Nomad

SERVICE BULLETIN

EQUIPMENT AND FURNISHINGS – IMPROVED CABIN TRIM RETENTION (MODIFICATION N682 [N22 SERIES] OR N682A [N24 SERIES])

Figure 1 Position of Panels Extrusions (N22 Series)

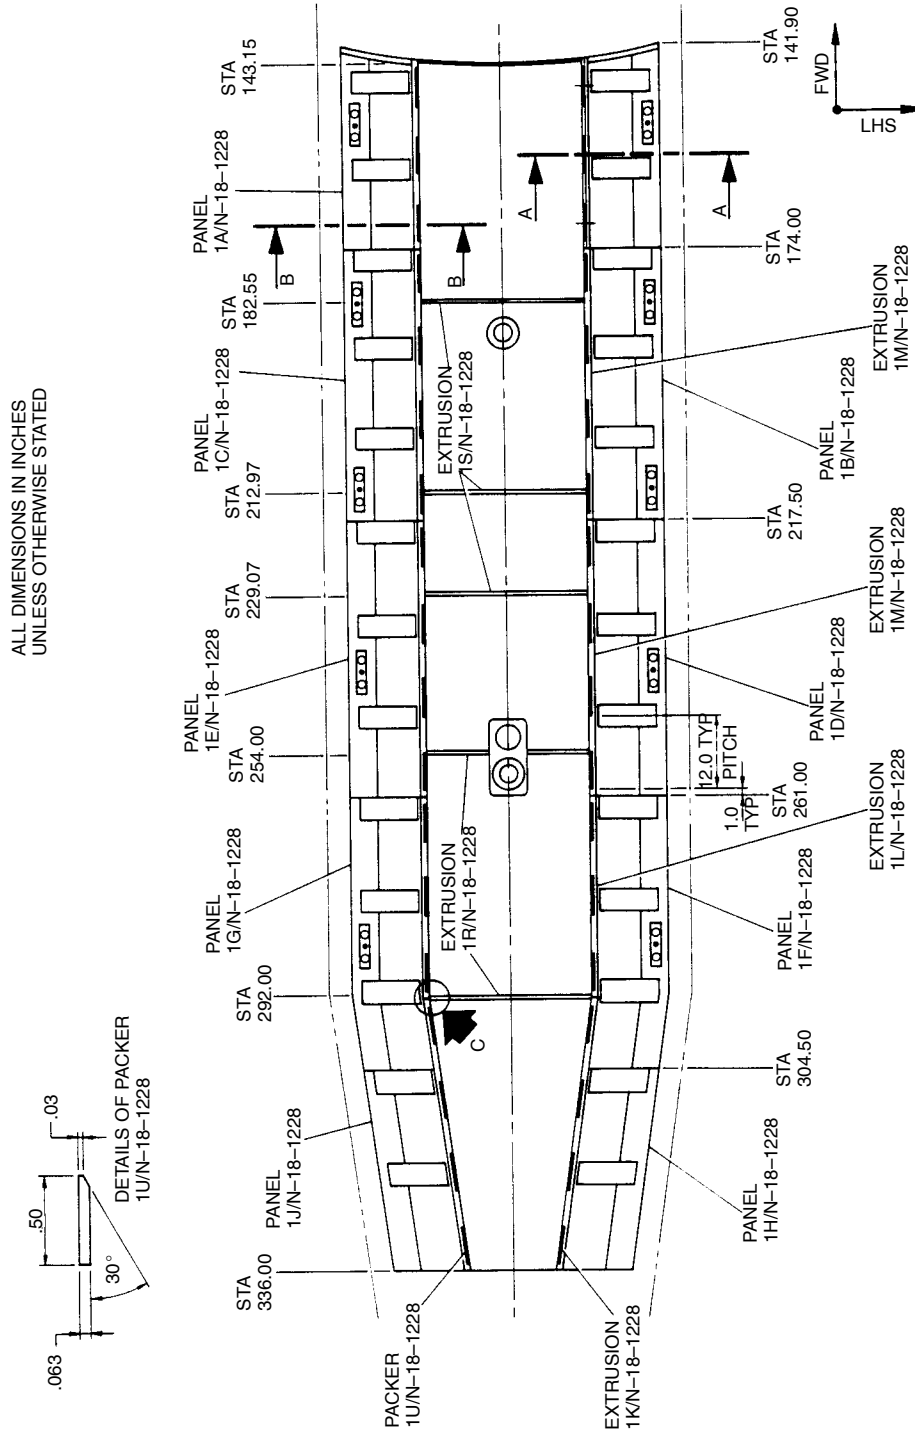
- D. Using aluminium extrusion SDX 49, cut the extrusions to length and part number, refer Para 3. Material Information.
- E. Bond the packers 1U/N-18-1228 to the overhead panels, using Araldite AW106/W953U, at 1.0 in from end of panel then at approximately 12.0 in pitch as shown in Figures 1 and 2. Packer details are shown in Figure 1.

Figure 3 Overhead Panels, Rework and Fitting Details

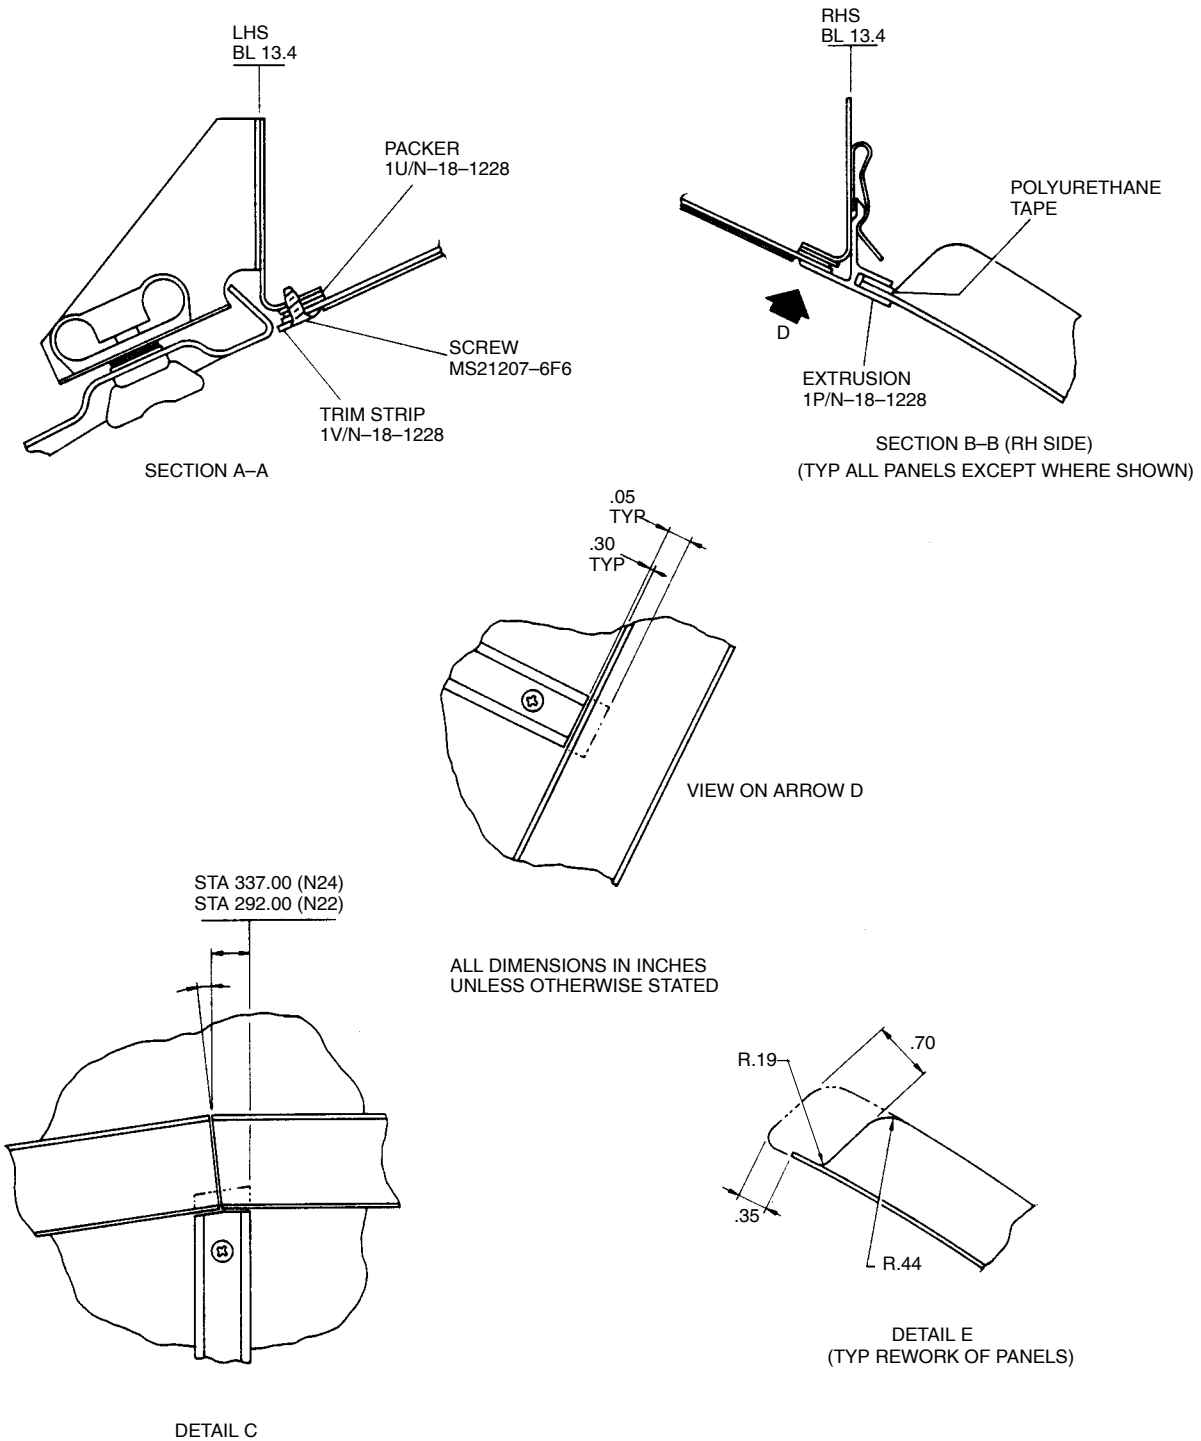
C. Remove the retaining flanges and rework overhead panels as shown in Figure 3, detail B. After rework, report number panels, refer to Para 3. Material Information.

- F. Apply polyurethane tape over the packers.
- G. Refit the overhead panels as detailed in MM Chap 25-20-00. During refitting it is necessary to trim the transverse extrusions 1B/N-18-571 and 1A/N-18-571 as shown in Figure 3, Section B-B. After rework, report number extrusions 1R/N-18-1228 and 1S/N-18-1228 respectively. At the forward LH side the panel is held in position by a trim strip 1V/N-18-1228, which is to be bonded to the panel with Araldite AW106/HV953U, and three MS21207-6F6 screws, refer to Figure 3, Section A-A.
